May 3, 2016
Subject: Bridge Replacement
State WIN: 020509.00
Location: **Haynesville**
Amendment No. 1

HAYNESVILLE BRIDGE
MATTAWAMKEAG RIVER
HAYNESVILLE AROOSTOOK COUNTY

DISC BEARINGS

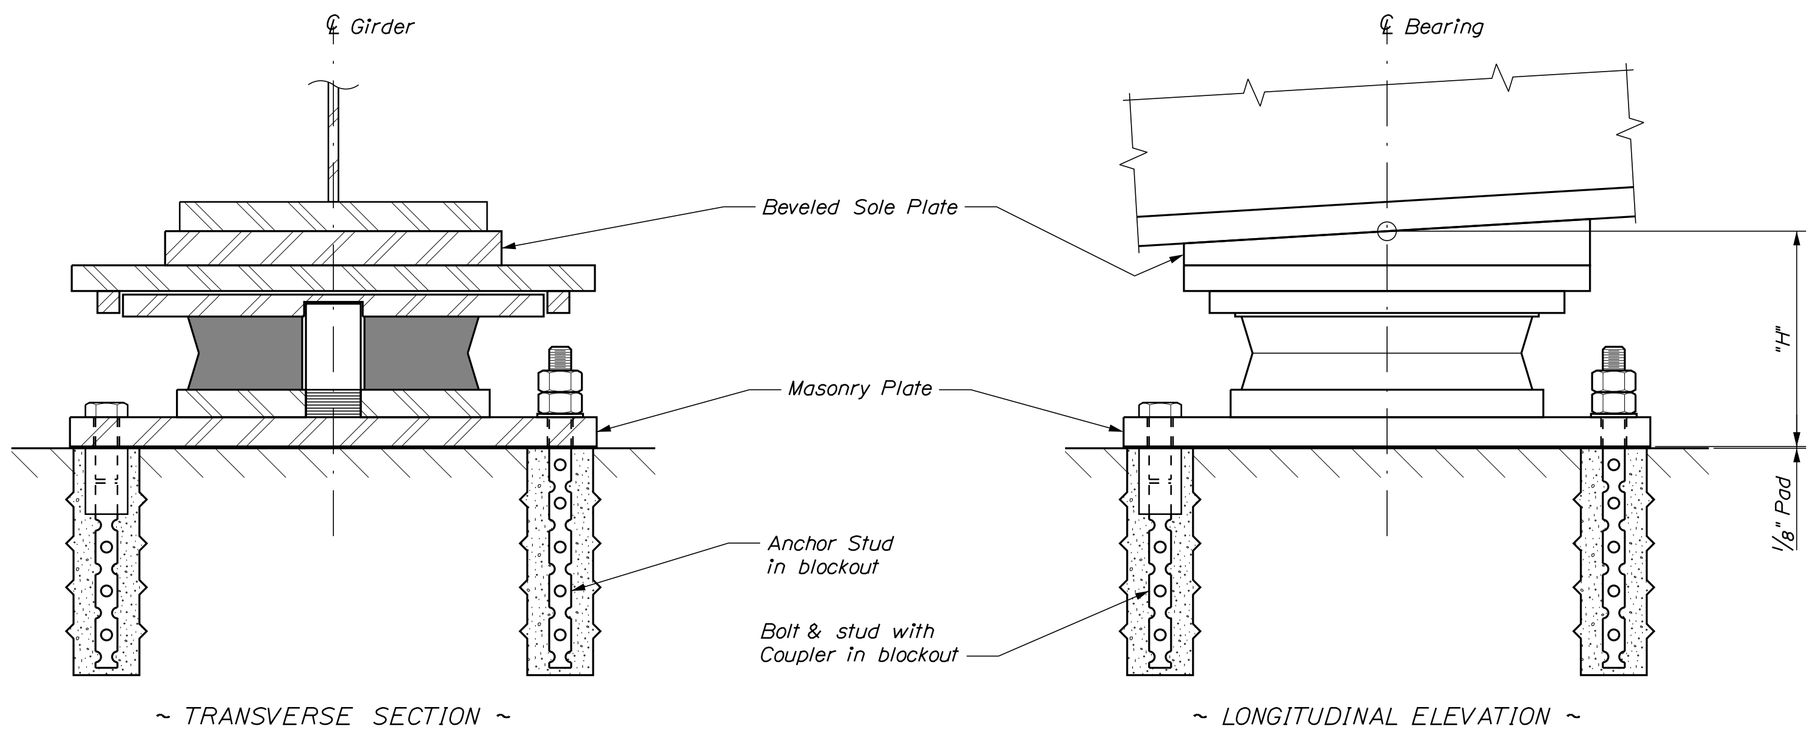
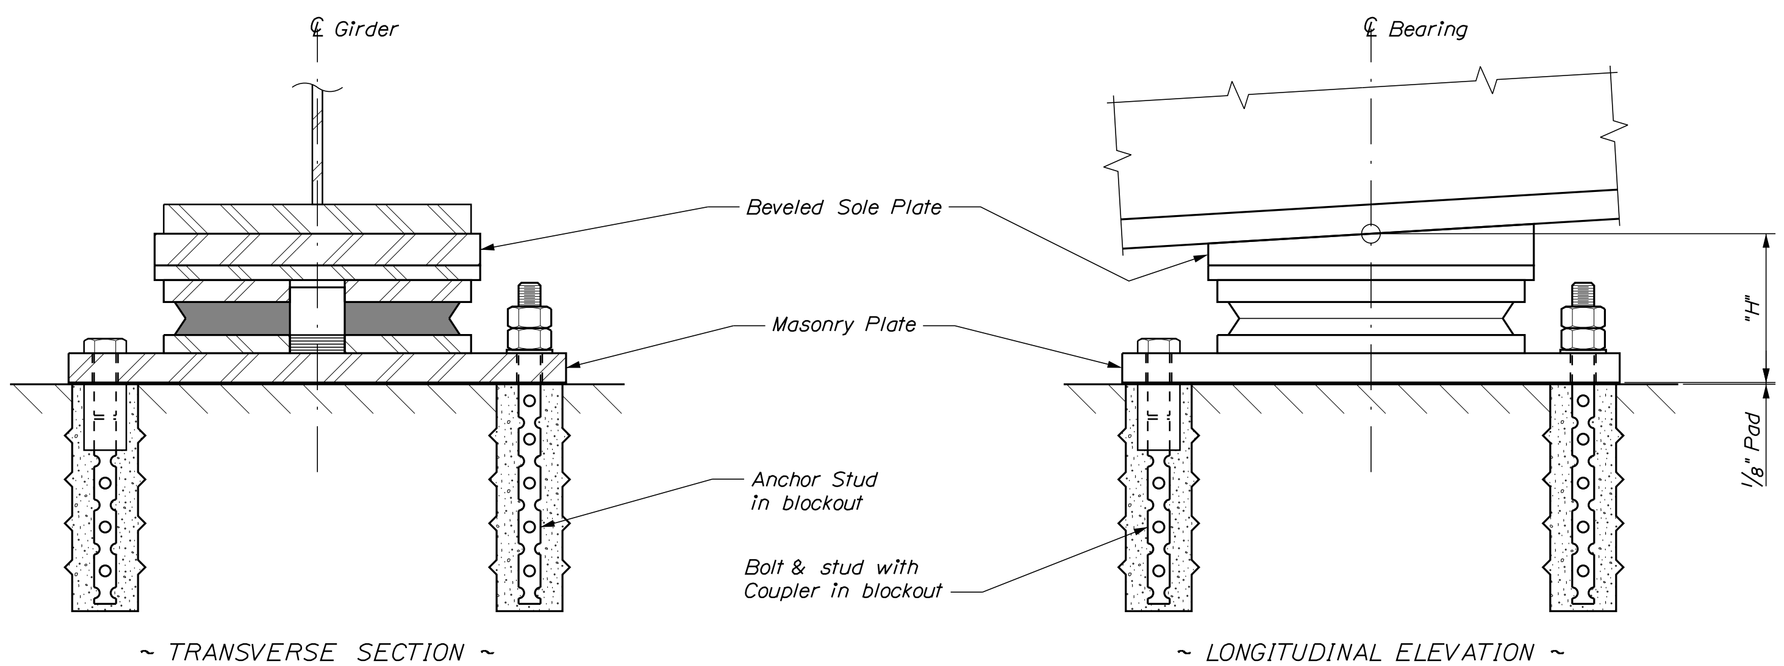
PROJ. MANAGER	M. WIGHT	BY	DATE
DESIGN-DETAILED	T. HJELM	LIBBY\MRP	MAR 2016
CHECKED-REVIEWED	B. REEVES	Team North	APRIL 2016
DESIGN2-DETAILED2			
DESIGN3-DETAILED3			
REVISIONS 1 △1	Disc Bearing Design Table 4/26/2016 & Setting Table Changes		
REVISIONS 2			
REVISIONS 3			
FIELD CHANGES

DISC BEARING DESIGN TABLE

Location	Bearing Type	Design Loads Per Bearing (kips)										Dim. "H" (in.) (Note No. 1)	Design Rotation (Note No. 19)		Total Long. Movement (in.)	Sole Plate Bevel
		Vertical				Horizontal										
		Strength	Extreme Event	Service		Strength		Extreme Event		Service			Service			
		Total Load	Total Load	Dead Load	Total Load	Longitudinal (Note No. 21)	Transverse	Longitudinal (Note No. 21)	Transverse	Longitudinal (Note No. 21)	Transverse		Rotation (radians)	Coincident Total Load (kips)		
Abut. No. 1	Uni-Directional	189	69	35	123	--	10	--	54	--	5		.0108	103	13/16	0.687
Pier No. 1	Fixed	270	112	64	194	60	21	55	84	45	10		.0086	160	--	0.273
Pier No. 2	Uni-Directional	270	112	64	194	--	21	--	84	--	10		.0086	160	1 1/16	0.273
Abut. No. 2	Uni-Directional	189	69	35	123	--	10	--	54	--	5		.0108	103	1 7/8	0.687

DISC BEARING SETTING CORRECTIONS TABLE

Dimension "X" (Inches)					
	15 °F	30 °F	45 °F	60 °F	75 °F	90 °F
Abut. No. 1	3/16	1/8	0	1/8	3/16	5/16
Pier No. 1	--	--	--	--	--	--
Pier No. 2	-1/4	-1/8	0	1/8	1/4	3/8
Abut. No. 2	-7/16	-1/4	0	1/4	7/16	11/16
